Our ref: 23020246-L01-V01

Addendum to Concept Flood Assessment and Stormwater Management Plan for Wyatt Road, Kagaru

Attachment 1 – Comparison of Concept Fill Vs RAL Fill

Comparison of RaL Bulk Earthworks and Context Plan Flood Extent

Figure 1 Context Plan

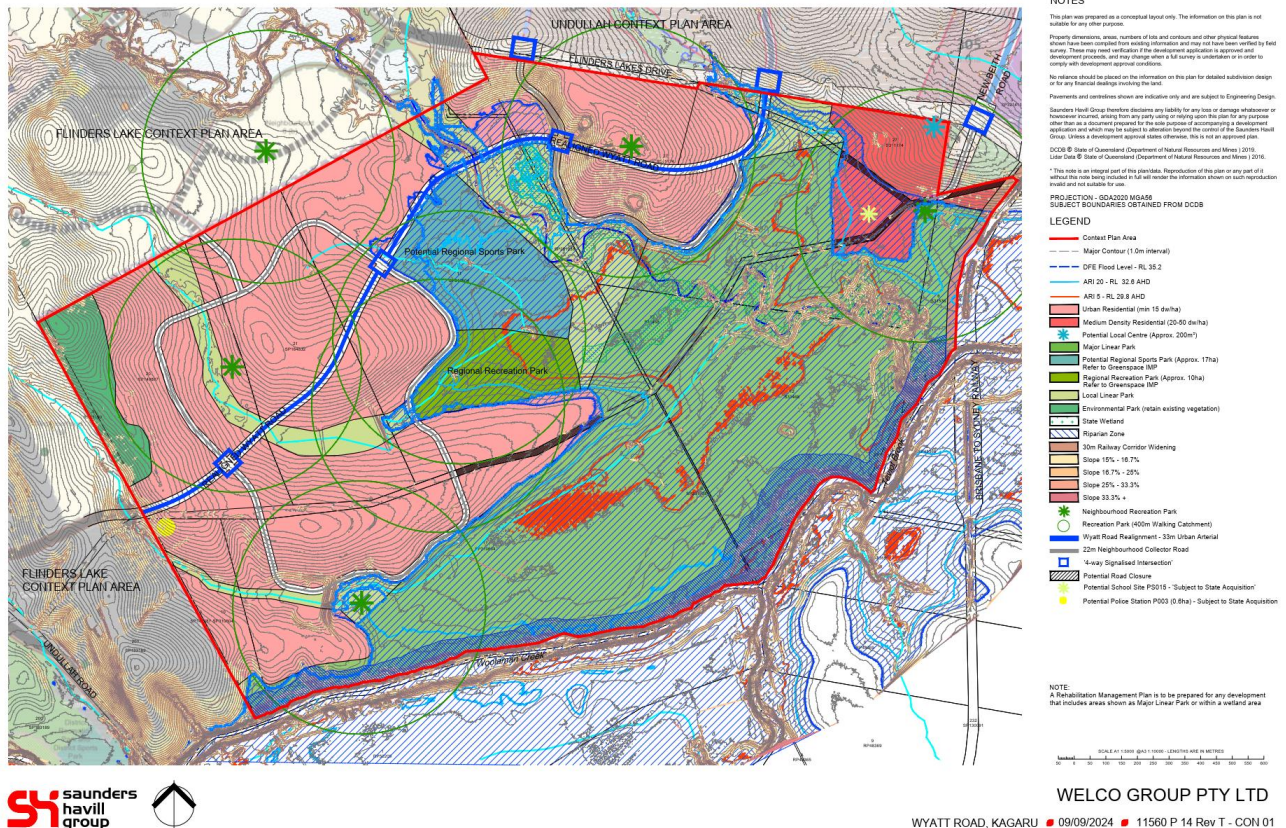
The bulk earthworks design associated with the RaL application, as prepared by Colliers, has been reviewed for consistency with the modelled fill extent associated with the context plan and used in both the regional and local flood assessments. The bulk earthworks design was found to be generally consistent with the Context plan, with the differences identified highlighted in **Attachment 1** with details as follows:

- The bulk earthworks design includes fill embankments for four (4) roads which cross either the floodplain or local waterways which were not represented in the context plan assessment

- These crossings were represented as 'gaps' in the road network as part of the Context Plan assessment. For all crossings, further design effort will be required to establish the required cross-drainage structures required. These could consist of culverts, box culverts, bridges (worst case) or a combination of structures. This can be established at a later design stage.

- The bulk earthworks design does not include filling in the far north-eastern corner of the context plan area which had been indicated with a potential school

- We understand that the intent is still for this filling to be included, however it does not form part of this RaL application.
- The bulk earthworks design includes several bioretention basins located outside of the previously assumed fill extent in the Context Plan assessment.

- These bioretention basins do not represent a significant extent of fill within the floodplain and will be located below the defined flood event level to minimise floodplain storage impacts. The basins are also located outside of any areas of significant conveyance of floodwaters. Inclusion of bioretention basins are not anticipated to result in any substantial differences in flooding outcomes documented in WT 2024.

- The bulk earthworks design includes a fill pad for the sewer pump station which was not previously included in the Context Plan assessment.
 - The extent of fill associated with the sewer pump station is relatively small and is located outside of areas subject to significant conveyance of floodwaters.

- The bulk earthworks design does not include the regional sports park
 - This has previously been accounted for in the context plan assessment.
- There are very minor variations between the bulk earthworks design and the context plan assumptions in relation to the line of fill associated with localised batter slopes.

- These variations are minor and are unlikely to be represented in the LARFS model due to the relatively 'coarse' grid size of the model (due to it being a regional flood model).

- Removal of an existing dam in the south-western part of the context plan area.

The above differences between the RaL bulk earthworks design and previously assessed Context Plan are considered minor with respect to the regional and local flood impact assessments previously prepared and documented in WT 2024 which is included as **Attachment 2**.
